2001 & UP SPACER PLATE

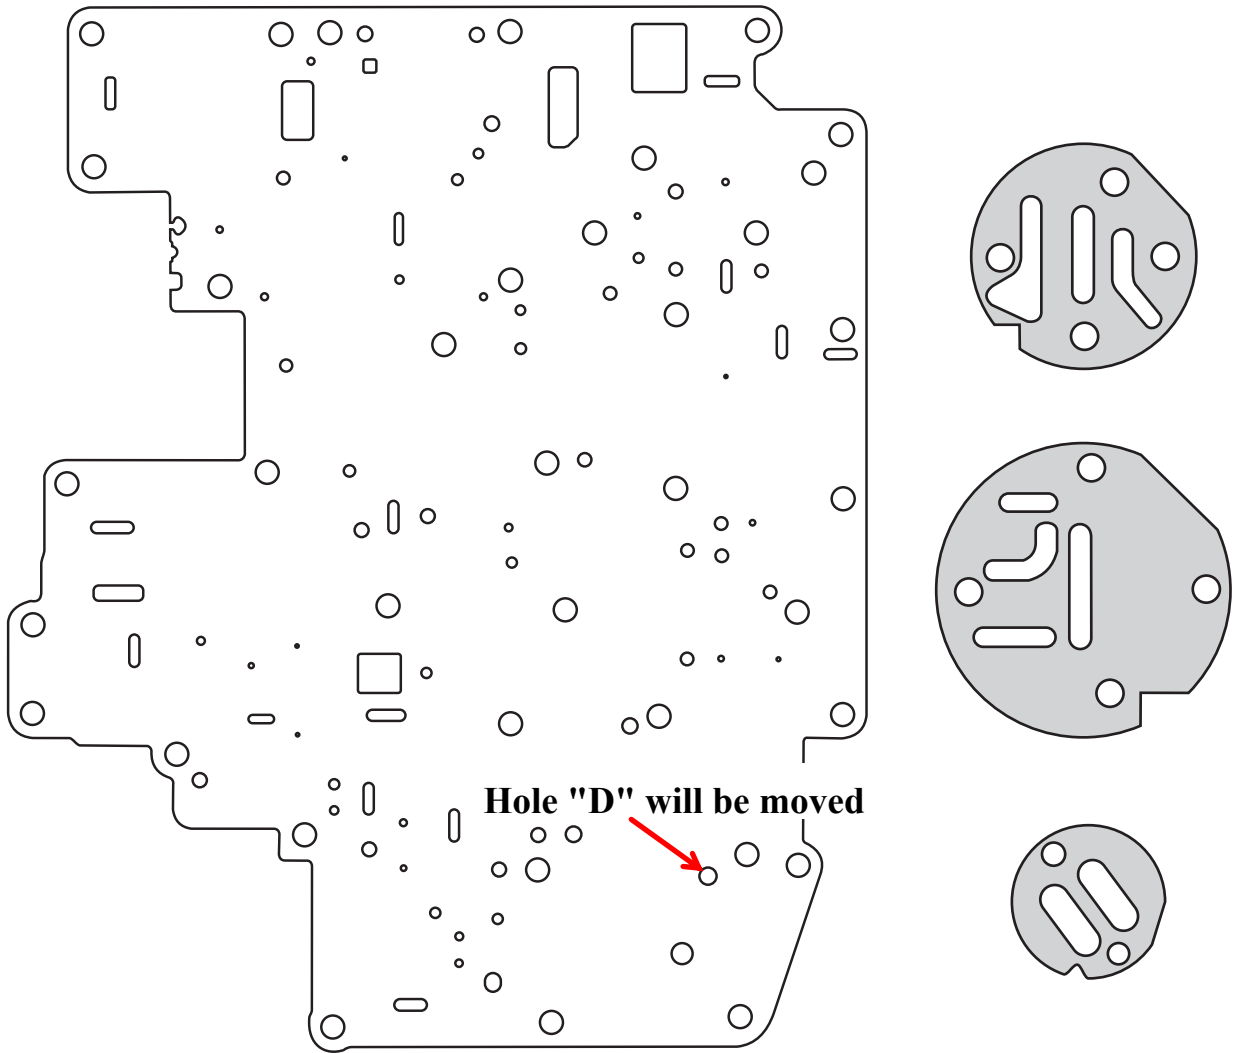
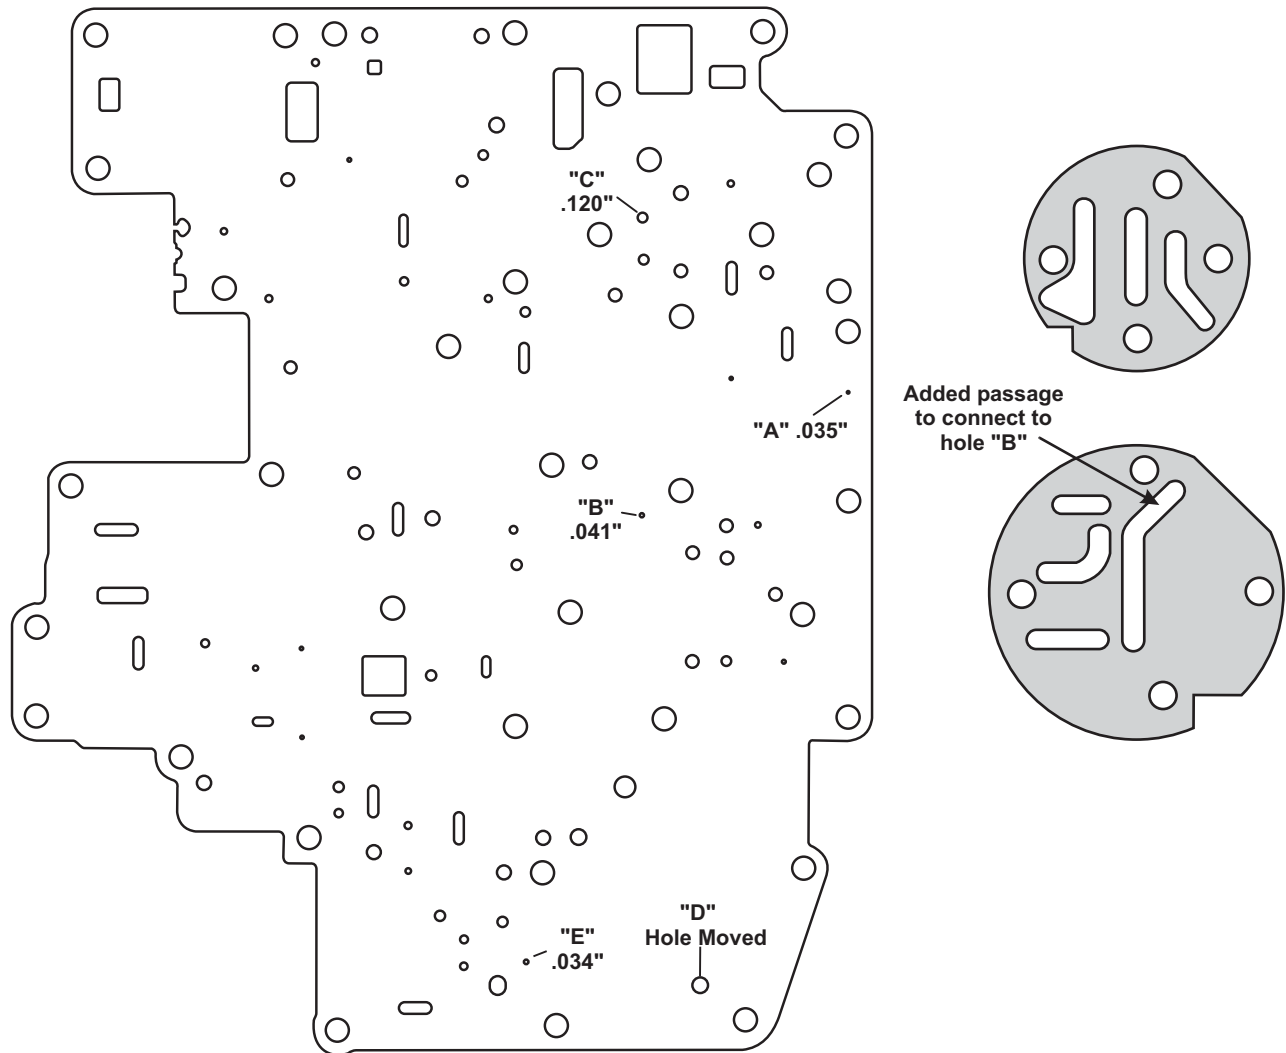
"A" = Added hole to connect the EPC circuit to the added Overdrive Servo Regulator Valve Boost Valve and Sleeve

"B" = Added hole to connect the Forward Clutch to the 3-4 Capacity Modulator Valve

"C" = Tcc Signal Pressure from TCC PWM solenoid. Hole was enlarged to .120"

"D" = Hole moved to connect the Direct Clutch to the Direct Clutch Accumulator

"E" = Orifice added to Direct Clutch Accumulator (Forward Clutch side)
